SUBJECT: Virgil C. Summer Nuclear Station
Docket No. 50/395
Operating License No. NPF-12
Relief and Safety Valves
NUREG-0737, II.D.1

Please find attached the South Carolina Electric & Gas Company (SCE&G) response to NRC questions dealing with NUREG 0737, item II.D.1. These question responses have been structured to provide the most concise and applicable answers to the NRC specific requests on the original submittal.

RESPONSES TO SAFETY EVALUATION QUESTIONS
TMI ACTION NUREG-0737 II.D.1
FOR V. C. SUMMER UNIT 1

Appendix A

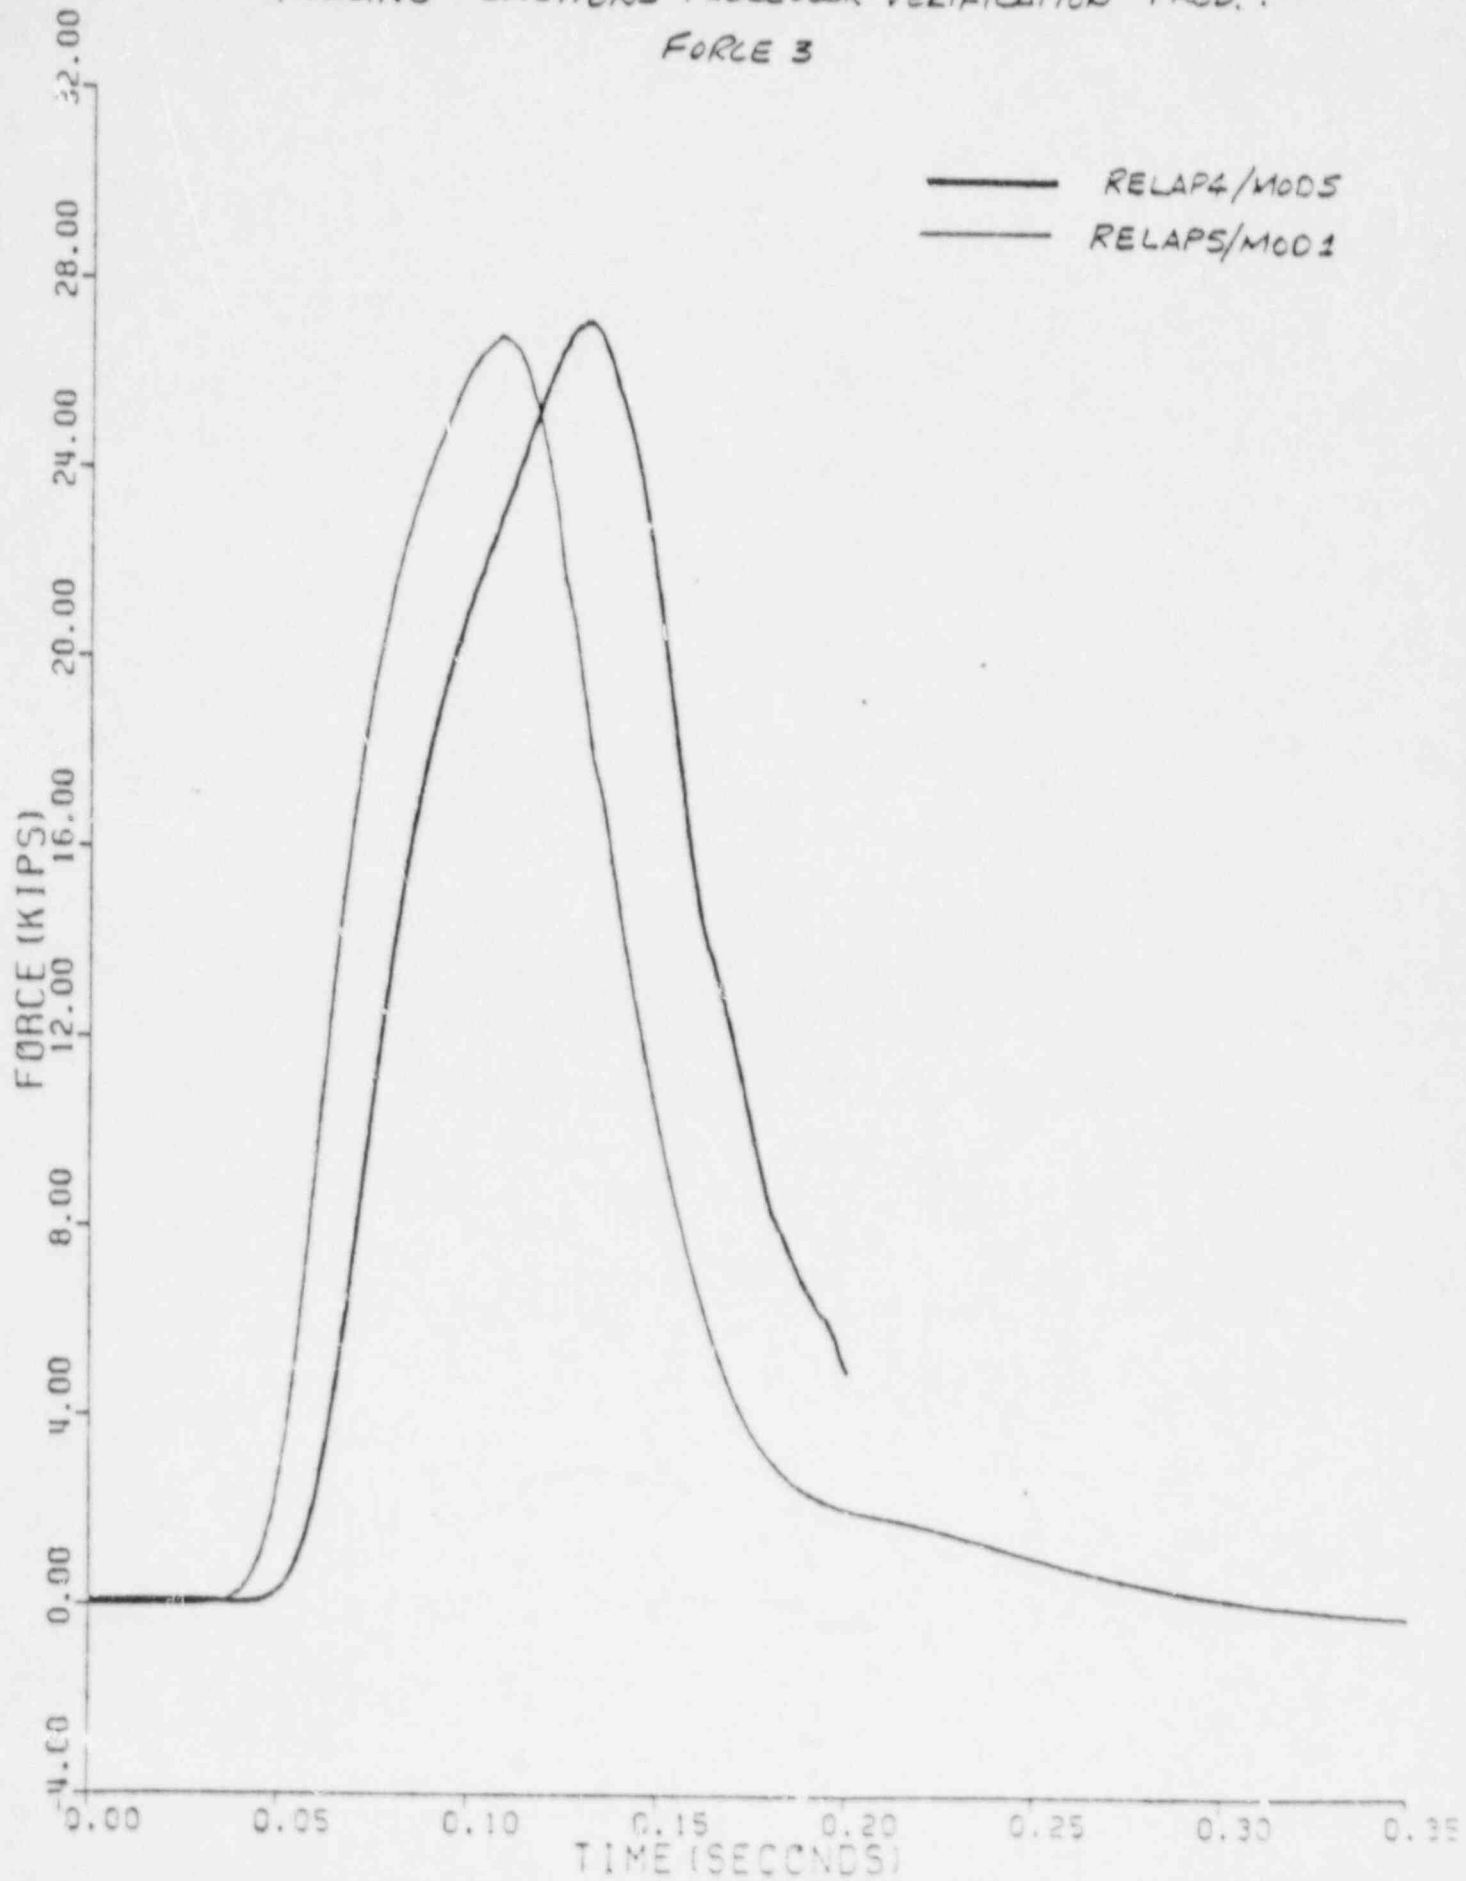
The submittal states that the thermal hydraulic analysis was performed using RELAP 5/MOD1 and that the RELAP 5 control system was used to calculate the fluid forces. Identify the methodology used to calculate forces from RELAP 5/MOD1 and provide additional verification that the methodology produces accurate force histories for similar problems.

Gilbert Associates, Inc. has developed a RELAP5/MOD1 processor for the evaluation of equations A-5 and A-6. This methodology has been verified by analyzing the steam line rupture given in Figure 3-3 which has also been analyzed by Moody², Strong and Baschiere³, and Burke and Webb⁴. Figures A-4, A-5, and A-6 compare the results of the analysis using RELAP5/MOD1 with answers reported previously by Burke and Webb⁴. The magnitude and timing of the forces compare favorably. The small differences seen are probably due to the inclusion of friction in the RELAP5/MOD1 model, which was not included in the other calculations.
